NEW ELEMENTARY SCHOOL
8601 HIGHLAND KNOLLS DR
BAKERSFIELD
CALIFORNIA
93306

**FIRE ALARM PLAN
BUILDING H**

E-131H

REQUEST:
RDM Electric - 12/27/12 RFI 237

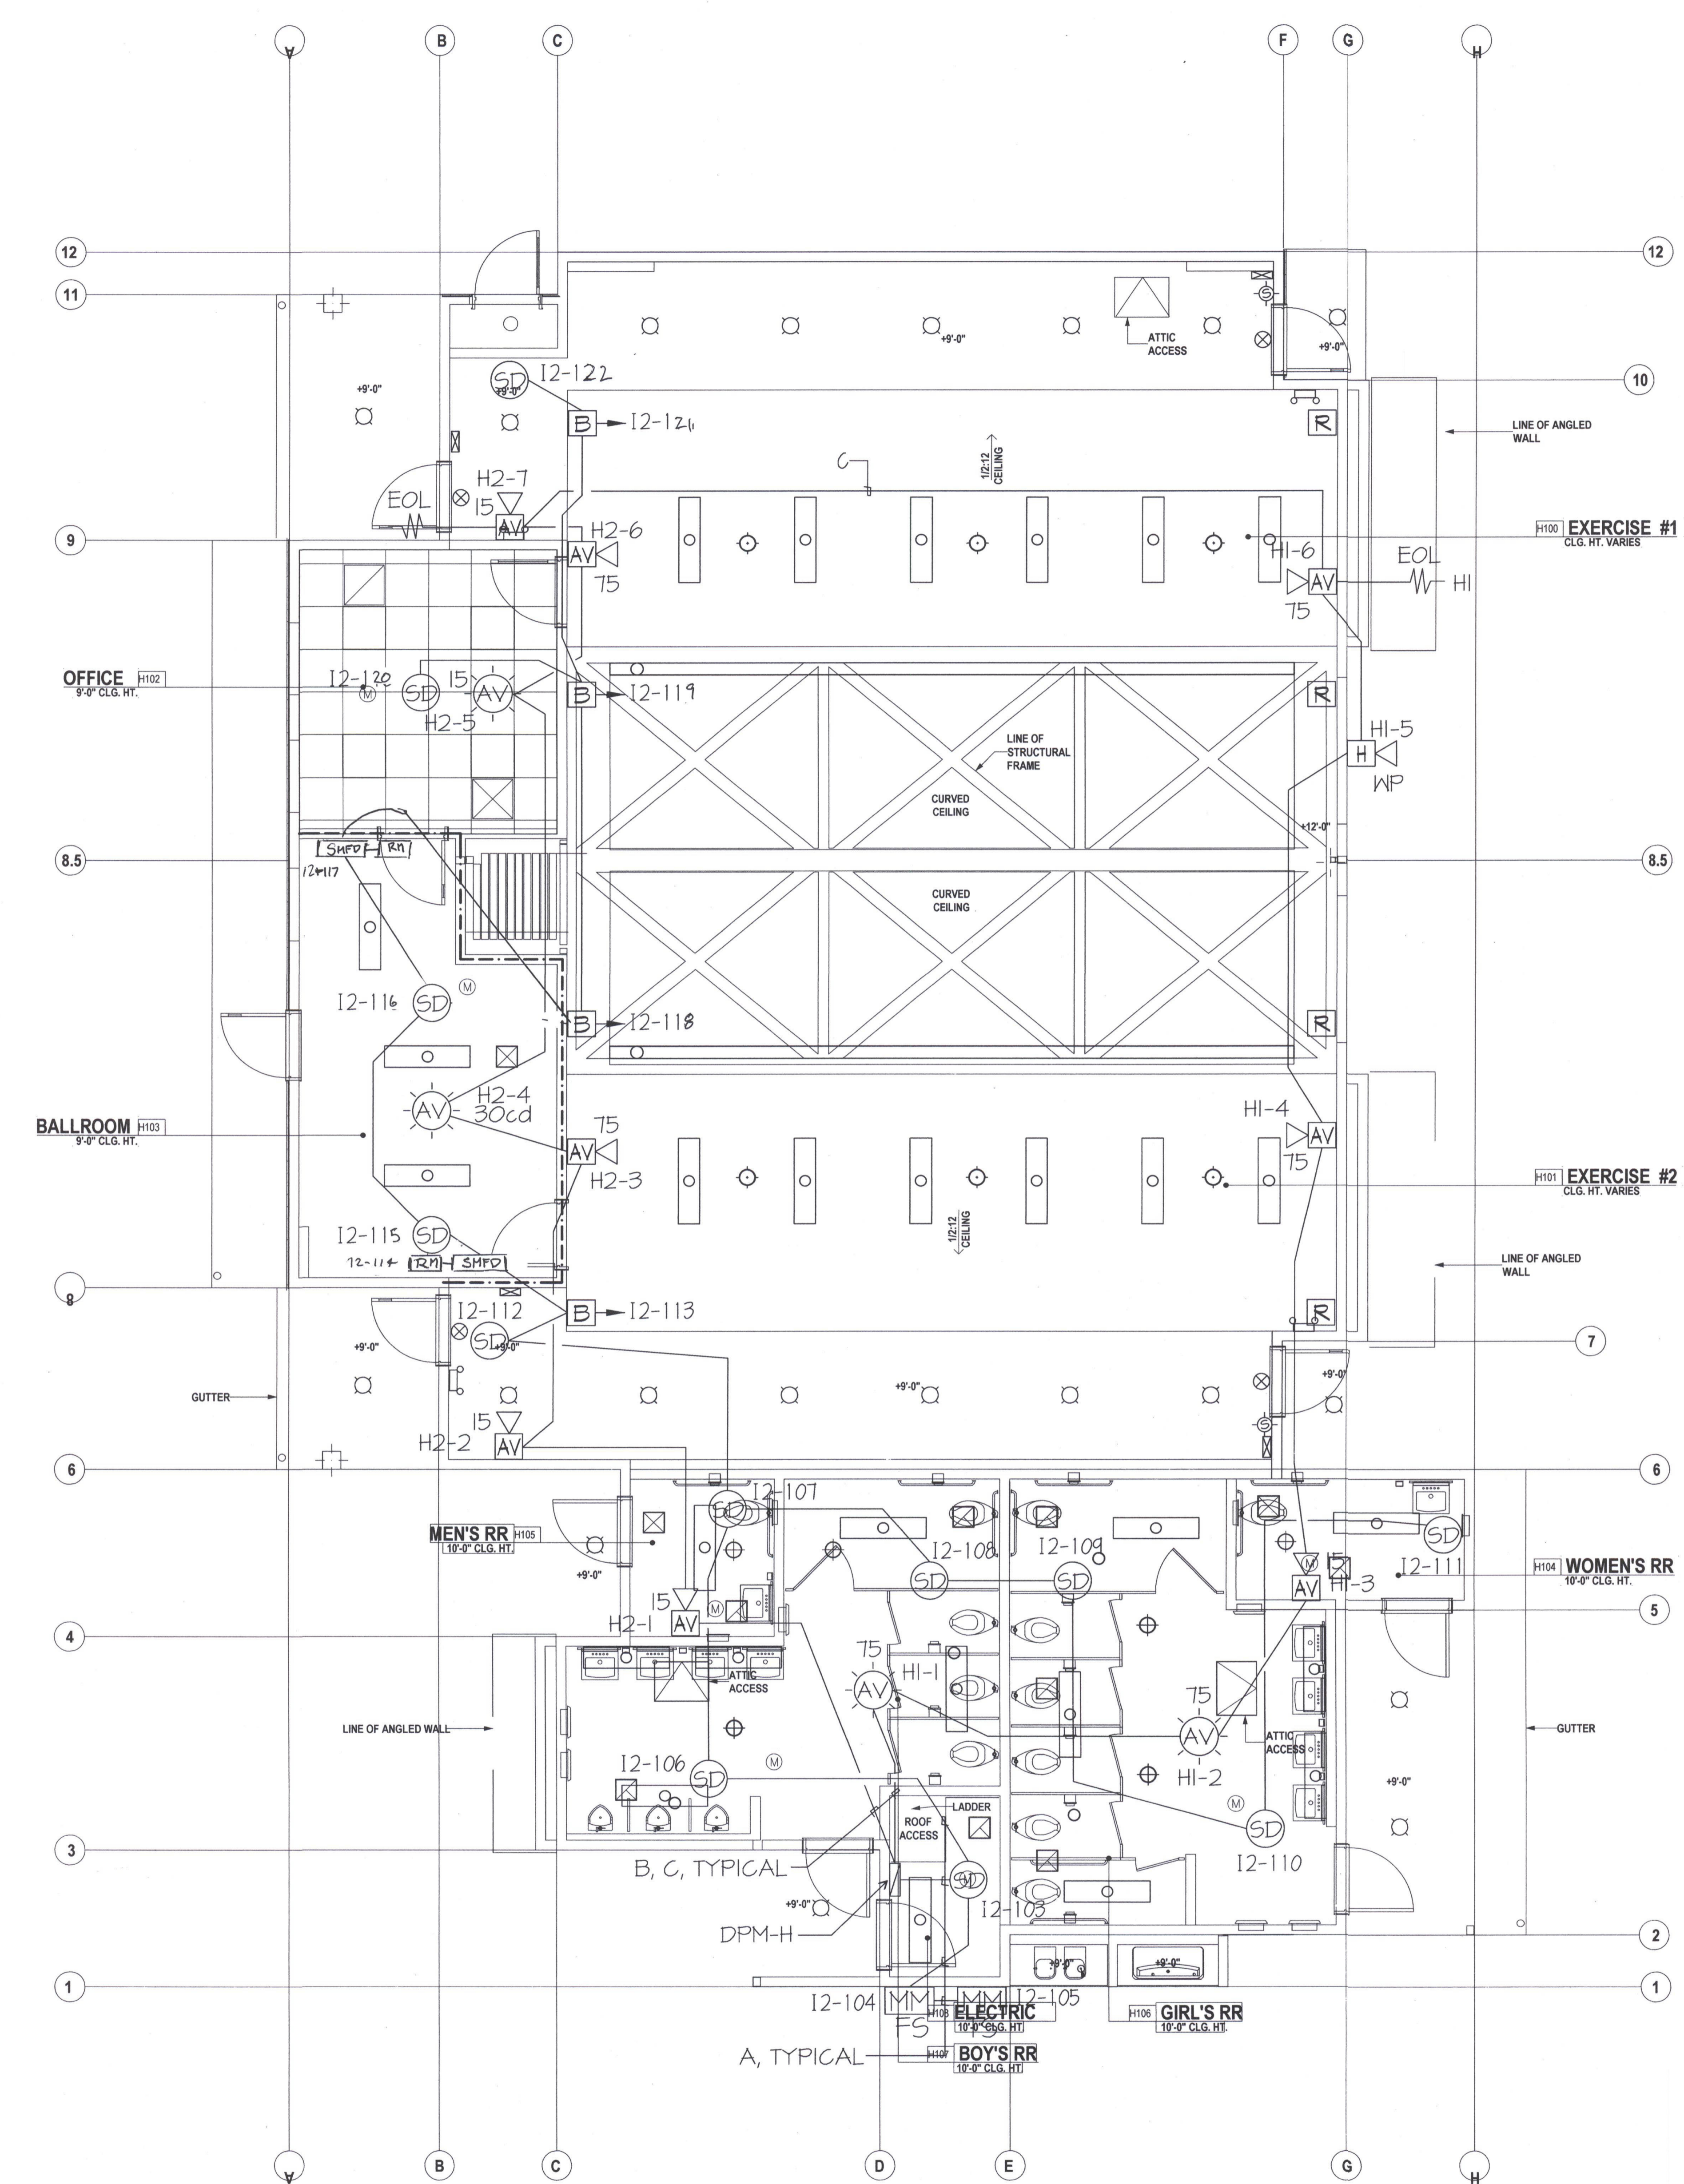
Reference A131H & E132H
The Architectural Plan for Building H shows (2) exterior light fixtures located just south of Room H106. However, the Electrical Plan for Building H does not show these light fixtures. Are they required? If so, please advise on the fixture type, quantity & size of conductive panel designation and circuitry.

ANSWER:
Ed Hewitt - OMA - 12/28/12
The lights questioned in RFI 237 are not required.
